Town of Bristol, Rhode Island

1200 Hope Street - Longfield

Modifications to original approved plan

1200 Hope Street & 1202 Hope Street - Drainage and Grading Revisions

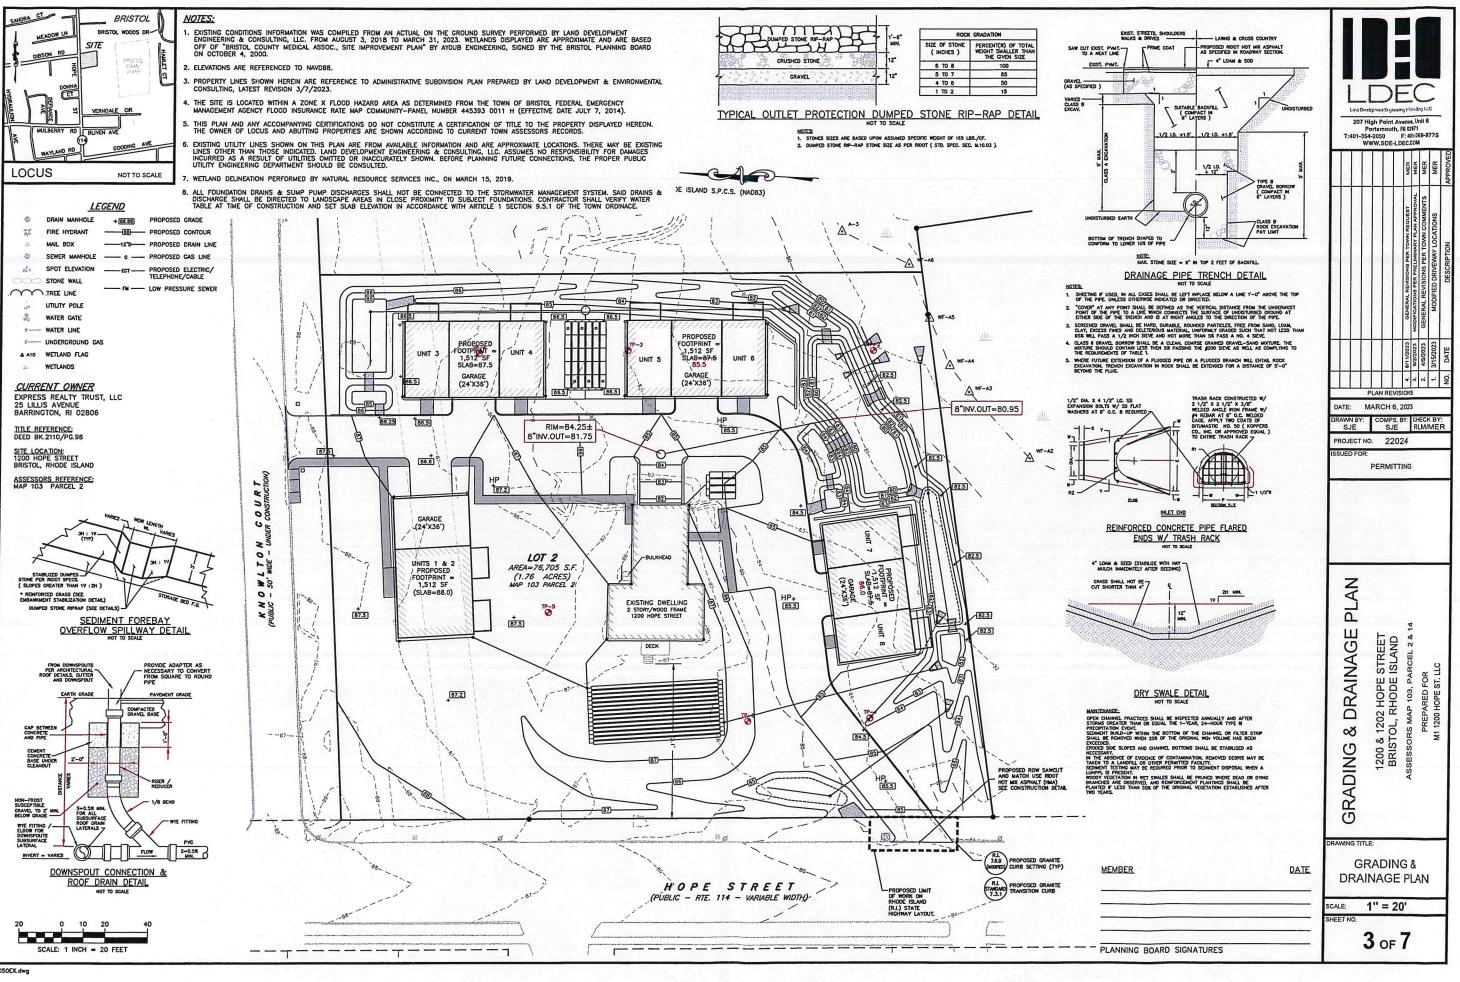
- 1. The revisions created a low point at the driveway of the existing dwelling. A trench drain is proposed to capture the flows from the driveway and discharge beyond the proposed BMP. The area appears to be negligible.

- 2. There is an additional "stormceptor" inlet proposed in the access drive proposed to discharge to the basin.
- 3. Units 3, 4, 5, and 6 shifted closer to the rear property line, reducing the proposed rear yard setback from 30' to 22'. The required rear setback is 50'. With this revision, the proposed decks for these units are now located over the backslope of a proposed swale.

- 4. Units 1 and 2 are shifted closer to the front property line, reducing the proposed front yard setback from 85.9' to 73.1'. The required front yard setback is 75', though the previously approved front yard setback is 73.1'. There is a note that Zoning Relief was received via Zoning Board Permit File No. 2018-41.

- 5. The access from Hope Street has been revised to have a reduced radius than the previously approved plan layout. A gate has also been proposed at this access entrance, limiting vehicular use. Design engineer should confirm that the required fire apparatus and other design vehicles can maneuver through the revised site layout.

- 3. The proposed decks for units 3, 4, 5 & 6 are being eliminated from the plan.
- 5. The proposed driveway access off Hope Street will be restricted to residents only with a turnaround proposed prior to the gated entrance to allow incidental access and the ability to turnaround & exit the site. Service and emergency access will be via the driveway access on Knowlton Court.

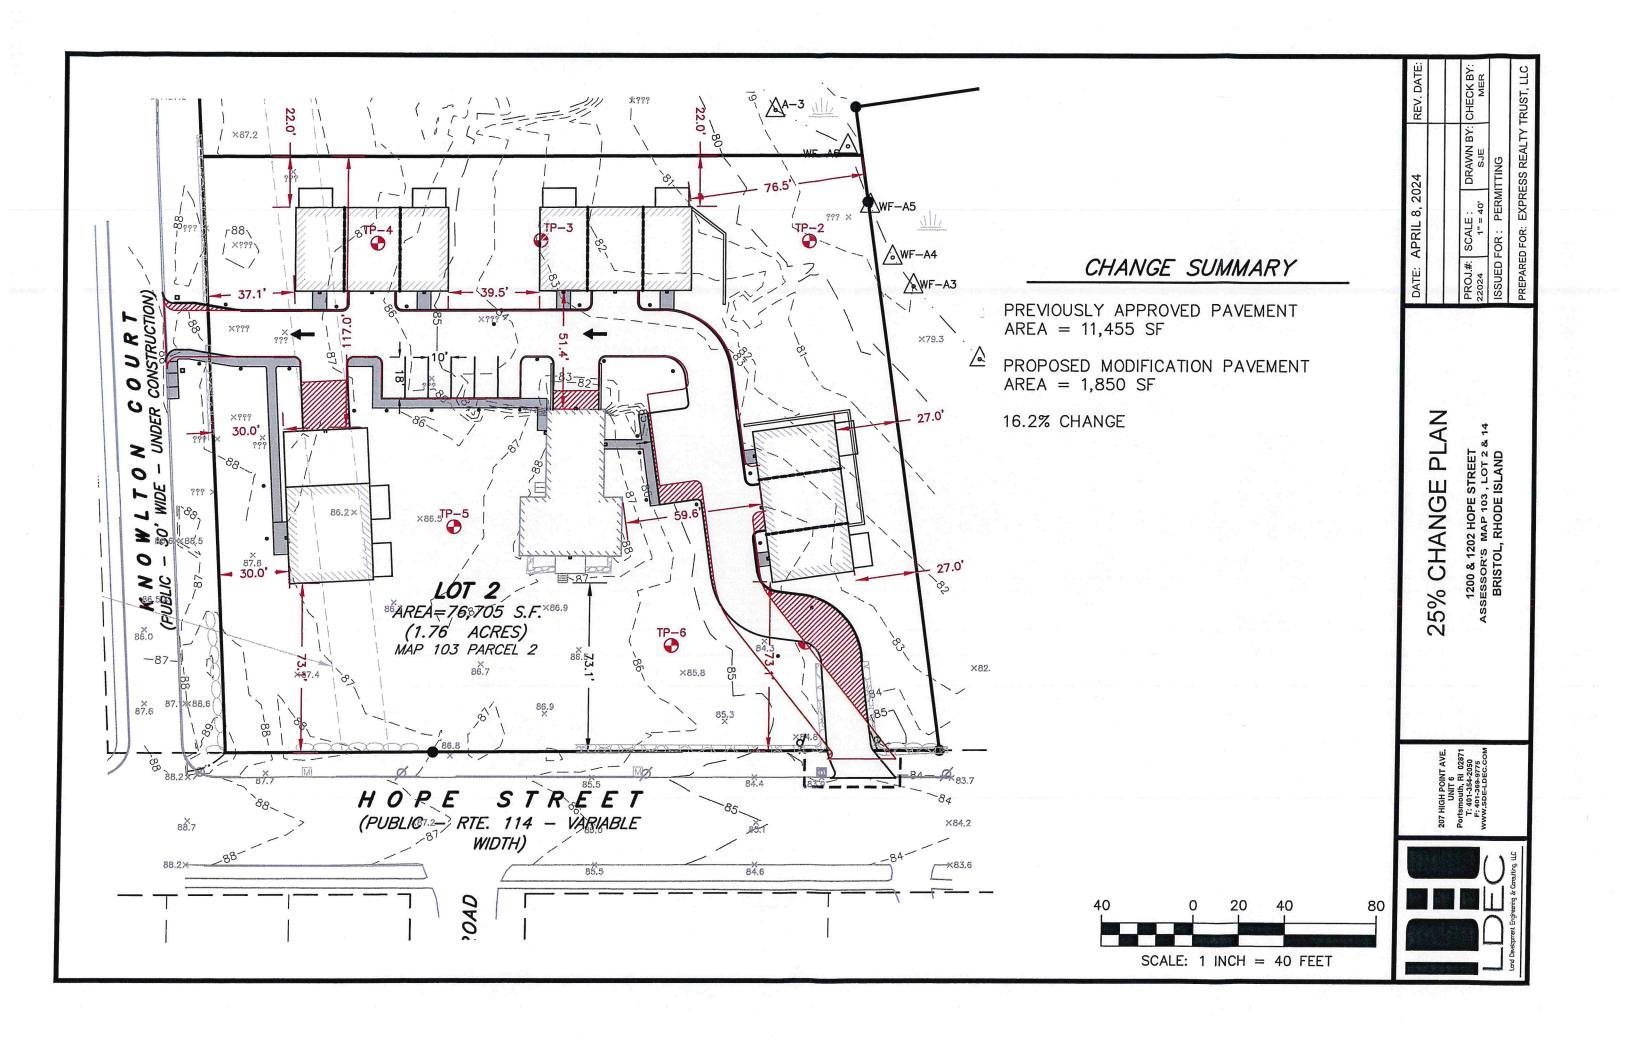
- 1. There is no increase the number of lots or dwelling units.
 - a. No increase
- 2. There is no change to any dimension of the plan, including building envelopes, exceeding twenty five percent (25%).
 - a. Building envelopes and relative position unchanged. Buildings shifted to originally permitted setback limits

Road alignment changes resulting in approximately 16% change from previous

- 1. Why is the driveway shifting with the curve to the south? I can let Kyle elaborate on this but essentially he constructed an entrance off of Hope Street that requires the inner driveway to be adjusted to match/connect, thus the referenced curve
- 2. Is the 16.2% change more pavement?

No, that represents the percentage of change in alignment relative to the overall driveway. The actual increase in pavement is 7.4%
